SERVICE BULLETIN

Subject: ELECTRICAL - MODEL A-9

Description: READING LAMPS

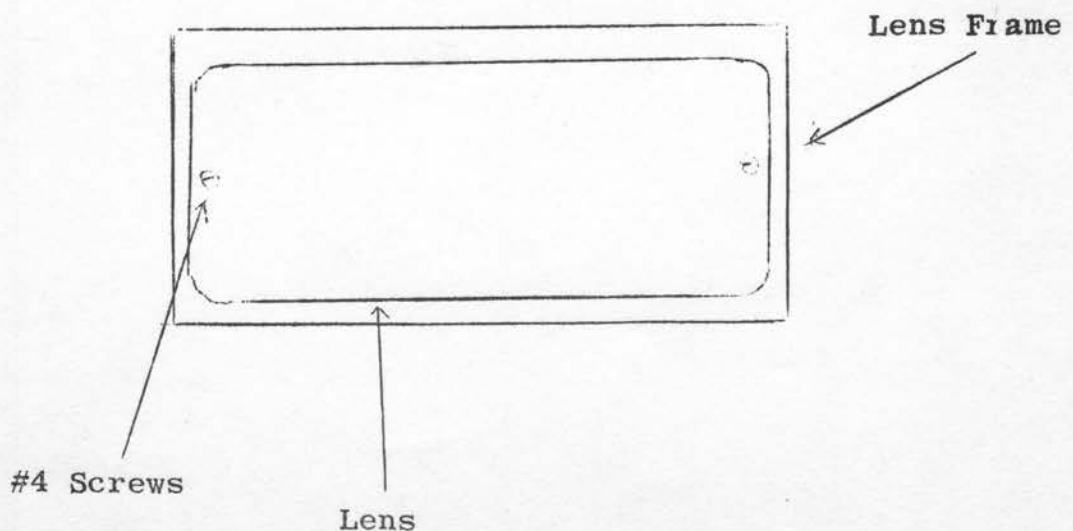
To prevent unnecessary loss of passenger and driver compartment reading light doors, the following procedure is recommended:

1. Drill a 1/16" hole through plastic door and into metal lamp housing at both ends.
2. Insert #4 (3/4" long) sheet metal screws.
3. Remove and replace screws whenever bulb replacement is required.
